DG-1327 Clarification

Reactivity Initiated Accident Guidance

EPRI Fuel Reliability Program, Reg-TAC Chair

January 25, 2017 • White Flint, Rockville MD

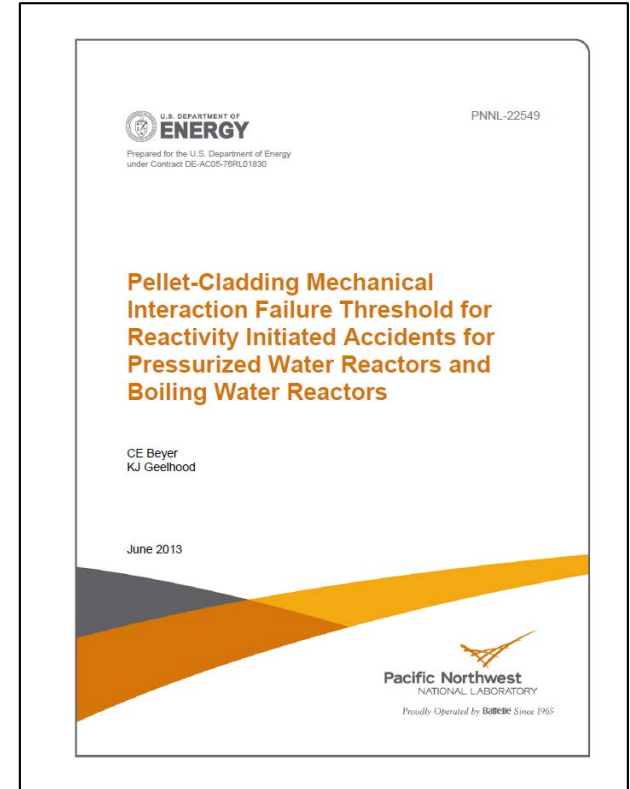
- **Best Estimate?**
 - Yes, in the sense that curve fits are relative to nominal data.
 - No, in the sense that the shape of curve fits displays negative impact in areas without failures
 - Low Hydrogen region
 - No, in the sense that correlation coefficients are in some cases substantially less than 1

Figure 6: Transient Fission Gas Release

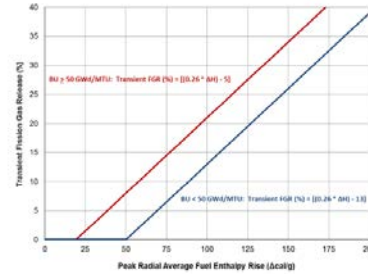
- Transient Fission Gas Release
 - Database doesn't represent low burnup
